BOC TO 12,700 MWD/ST MINIMUM CRITICAL POWER RATIO (MCPR) VERSUS TAU AT RATED FLOW FIGURE 3.2.3-1

FERMI - UNIT ? 9910270150 891019 DR ADOCK 0500 341 PDC 3/4 2-8

Amendment No. 39,42

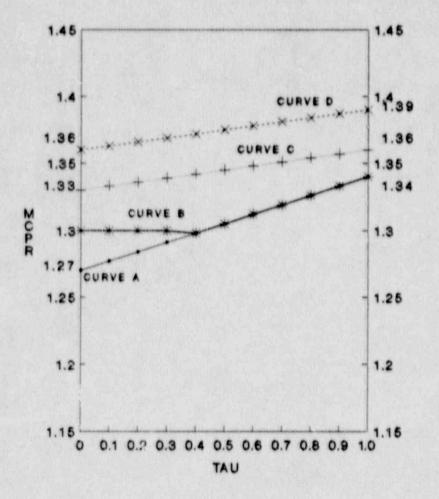
CURVE B - MCPR limit for non-CCC operational mode with both turbine bypass and moisture separator reheater in service.

- CURVE C MCPR limit for both CCC or non-CCC operational modes without either turbine bypass or moisture separator reheater.
- CURVE D MCPR limit for both CCC and non-CCC operational modes without both turbine bypass and moleture separator reheater.

CURVE A - MCPR limit for CCC operational mode with both turbine bypass and moleture separator reheater in service.

MINIMUM CRITICAL POWER RATIO VERSUS TAU AT RATED FLOW FIGURE 3.2.3-18

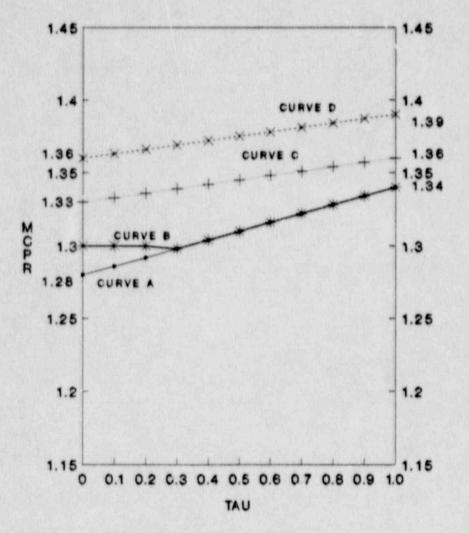
CURVE A - MCPR limit for CCC operational mode with both turbine bypass and moisture separator reheater in service. CURVE B - MCPR limit for non-CCC operational mode with both turbine bypass and moleture separator roheater in service. CURVE C - MCPR limit for both CCC and non-CCC operational modes without either turbine bypass or moisture separator reheater. CURVE D - MCPR limit for both CCC or non-CCC operational modes without both turbine bypass and moisture separtor reheater. 13,700 MWD/ST TO EOC
